May 2, 2024

Subject: **Response to Request for Additional Information** for the Proposed Replacement of Bridge No. 9 over Blounts Creek on Mouth of Creek Road (SR 1112) in Beaufort County, North Carolina; TIP No. B-5614, Federal Aid Project No. 1112019; WBS 45569.1.2

Revised Bridge Drawings

Sheet 1 of 5

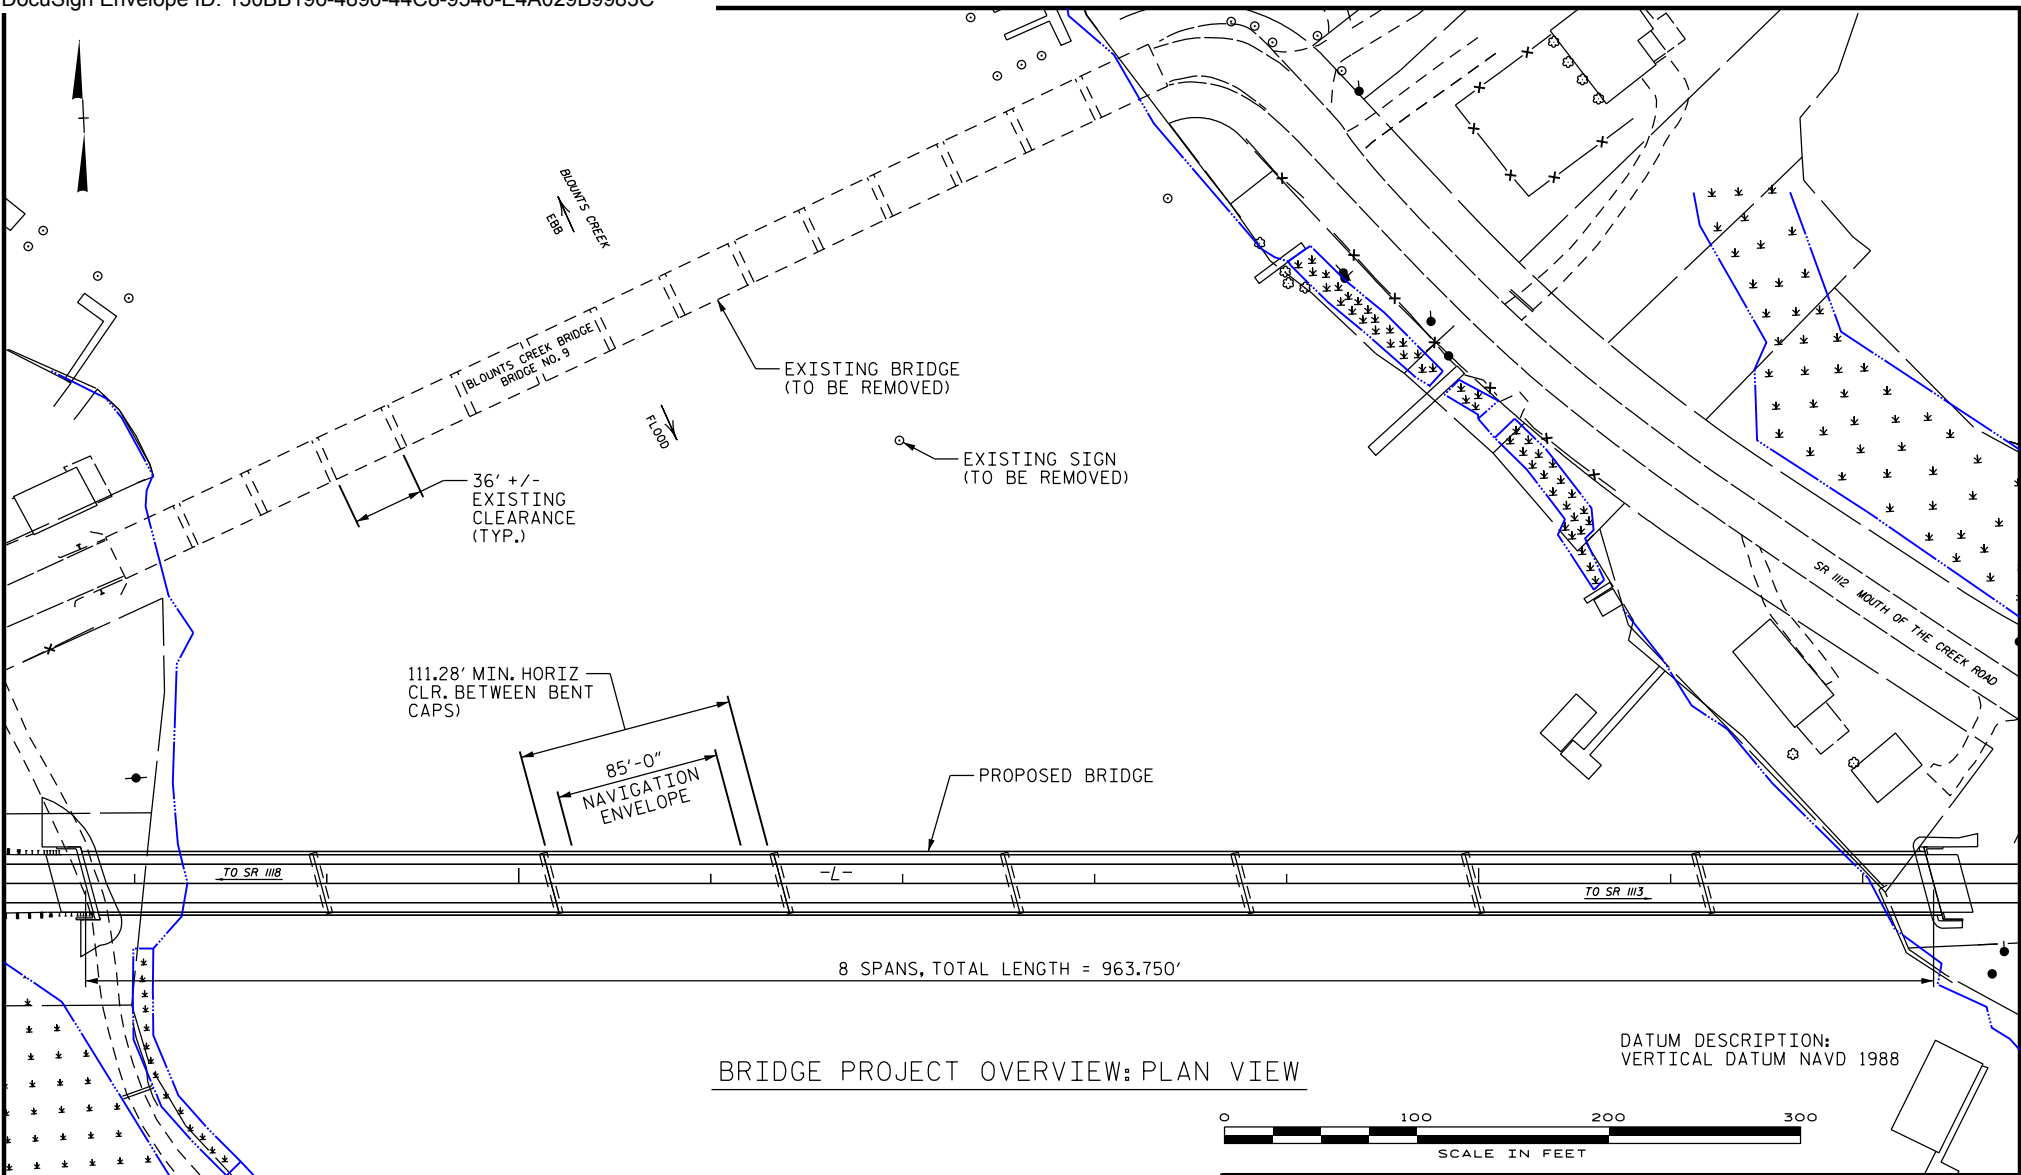
Job Aid: Section 3, Location/ Vicinity Map, Checkbox 4:

Please depict the ebb/flood on Sheet 1 of 5.

NCDOT Response:

This has been added to the Sheet 1 of 5.

Sheet 2 of 5

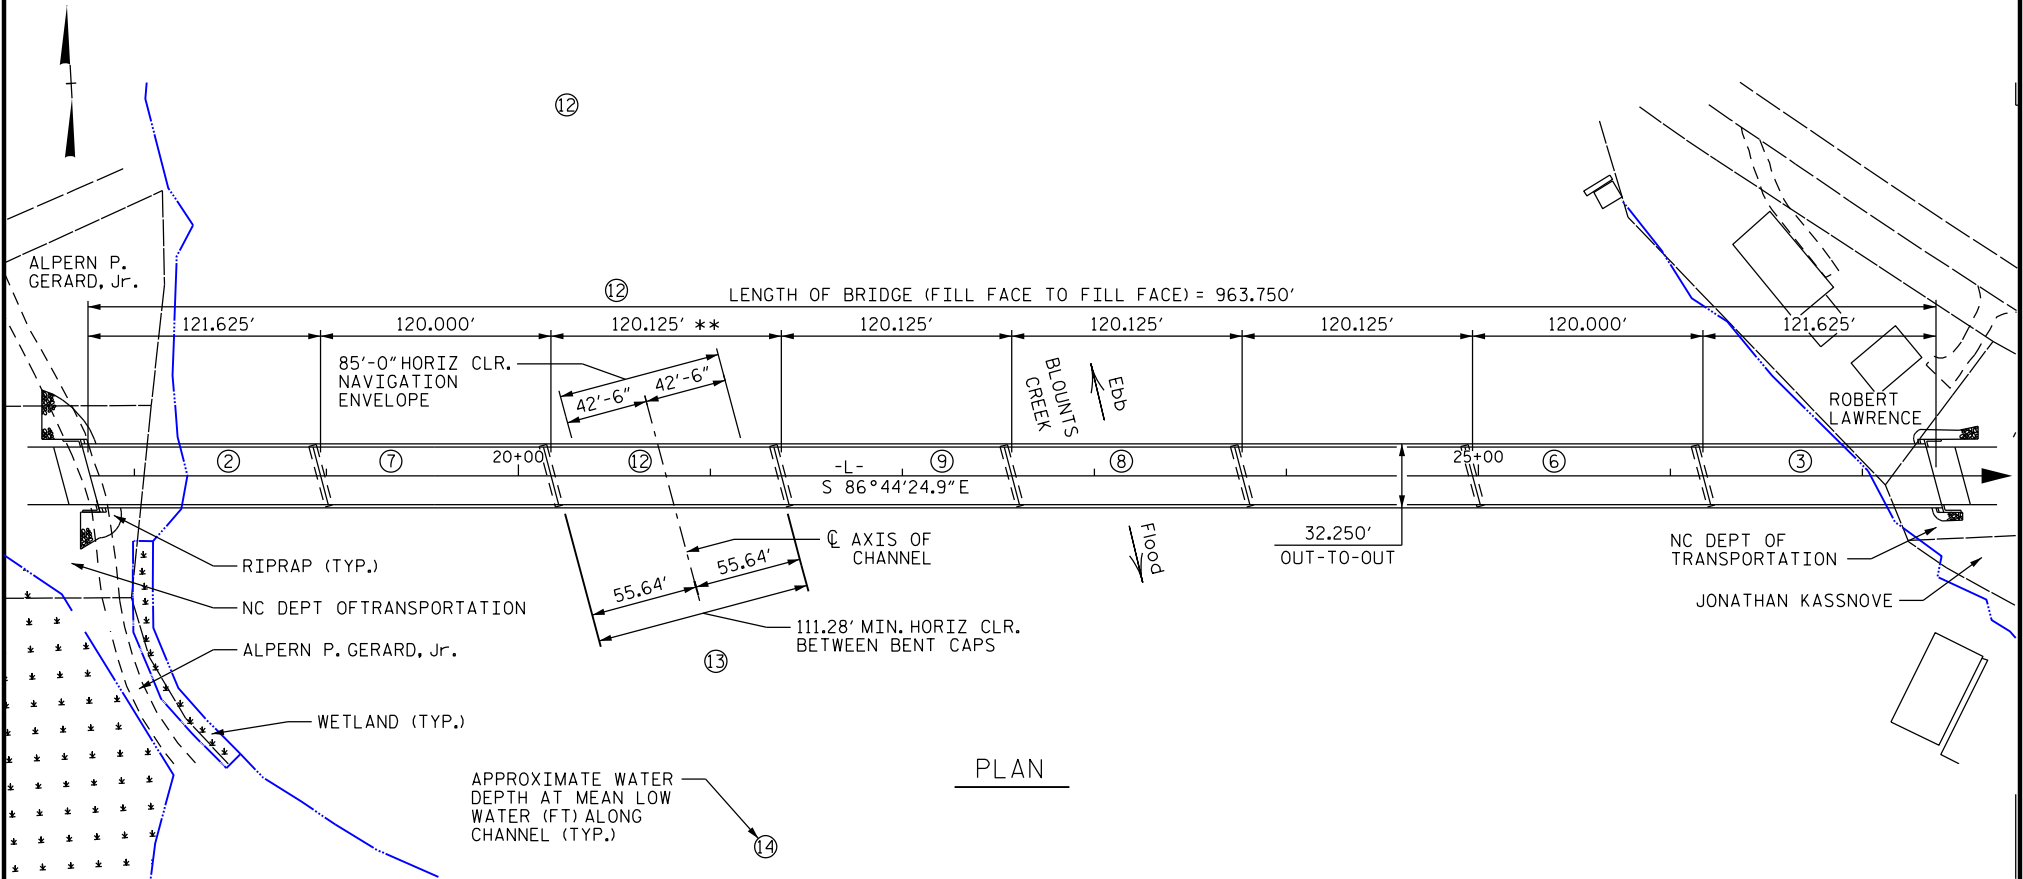
Job Aid: Page 2:

Label Sheet 2 of 5: “Bridge Overview: Plan View”

NCDOT Response:

This title has been added to Sheet 2 of 5.

Sheet 3 of 5

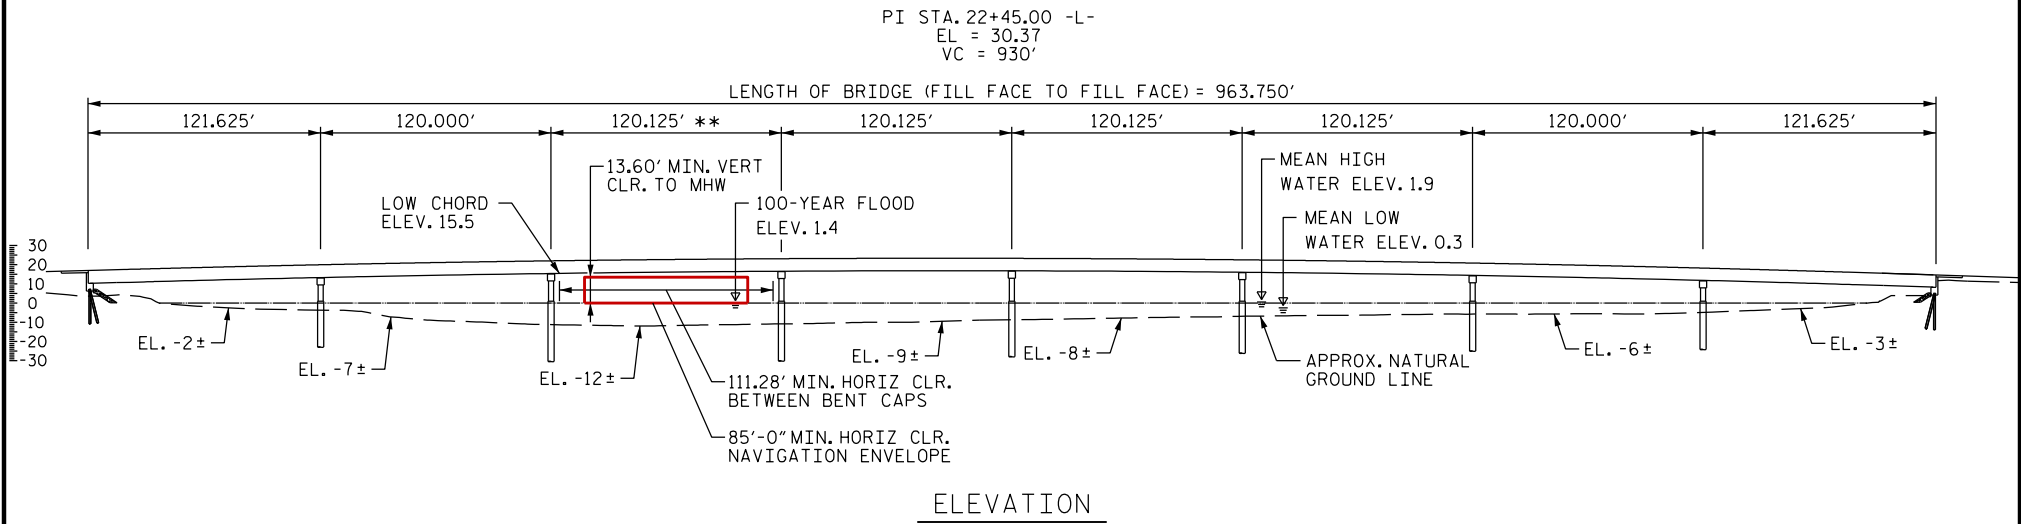
Job Aid: Section 4. Plan View, Checkbox 5:

Please identify/label the mean high water and mean low water lines on Sheet 3 of 5.

NCDOT Response:

Pursuant to the guidance, and meeting on March 26th, it was understood that since the difference in the mean high and low water elevation is minimal to the slope of the waterway banks, only one water line will be displayed.

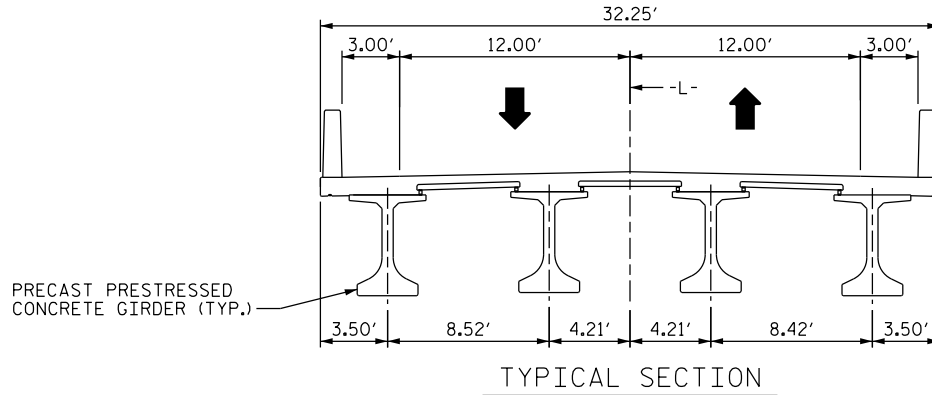
<p>Job Aid: Section 4, Plan View, Checkbox 11 AND 13: Please define the “minimum” horizontal clearance through the 3rd span from the west abutment (leave room for installation of a fender system, in the case one is needed in the future,; this office would like to see a horizontal clearance of 80 or 90 feet to leave room for a fender system.</p>
<p>NCDOT Response: Per request of the USCG, NCDOT has reduced the horizontal clear navigation envelope to 85 feet to allow for a future fender system, should one be deemed necessary in the future.</p>
<p>Job Aid: Section 4, Plan View, Checkbox 14: Please show water depths at various locations in the channel, upstream and downstream of the bridge on Sheet 3 of 5.</p>
<p>NCDOT Response: Water depths have been added to Sheet 3 of 5.</p>
<p>Job Aid: Section 5, Elevation View: Remove Base HW (0100) elevation and WSE elevation, and the 2.8466%, the triangle, and the - 3.1745%; Please define the “minimum” horizontal clearance through the 3rd span from the west abutment (leave room for installation of a fender system, in the case one is needed in the future,; this office would like to see a horizontal clearance of 80 or 90 feet to leave room for a fender system) on Sheet 4 of 5.</p>

<p>NCDOT Response: The requested items have been removed. Per request of the USCG, NCDOT has reduced the horizontal clear navigation envelope to 85 feet to allow for a future fender system, should one be deemed necessary in the future.</p>
<p>Job Aid: Section 5, Checkbox 4 AND 5: Please see comment under “Elevation View” heading regarding leaving room for installation of a fender system in the future.</p>
<p>NCDOT Response: Per request of the USCG, NCDOT has reduced the horizontal clear navigation envelope to 85 feet to allow for a future fender system, should one be deemed necessary in the future.</p>
<p>Job Aid: Section 5, Checkbox 10: Please insert and label the 100-year flood elevation on elevation view Sheet 4 of 5 in the 3rd span from the west abutment.</p>
<p>NCDOT Response: The 100-year flood elevation has been added to Sheet 4 of 5.</p>
